SERVICE BULLETIN

No. Q99 under BRAKES

BRAKE DUST SHIELDS

(All With FA(W)616C, 617C Front Axles)

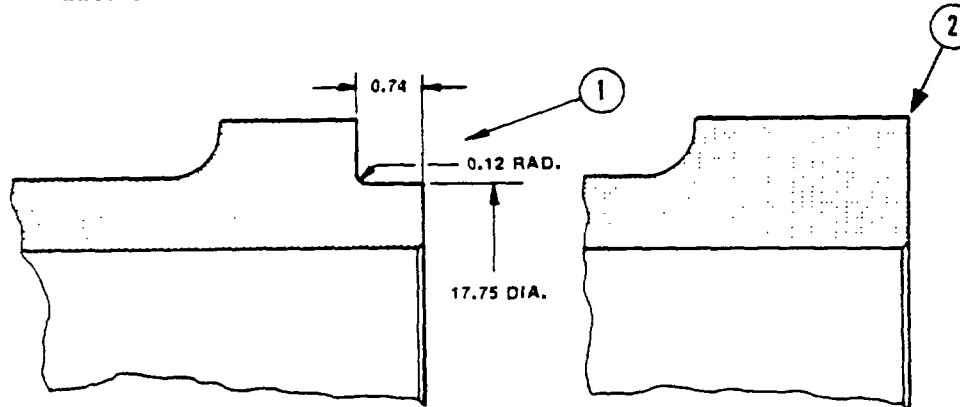
Dust shields can be installed without modification on current production vehicles. To install shields on non-current vehicles it is necessary to modify existing brake drums or replace them with current production drums. Current production drums have a relief on inboard side that provides clearance for the shields. A similar relief can be added to non-current drums if desired. See illustration for dimensions.

1. CURRENT PRODUCTION BRAKE DRUMS ARE RELIEVED IN THIS AREA TO PROVIDE CLEARANCE WITH SHIELD.
2. NON-CURRENT PRODUCTION BRAKE DRUMS DO NOT HAVE A RELIEF.
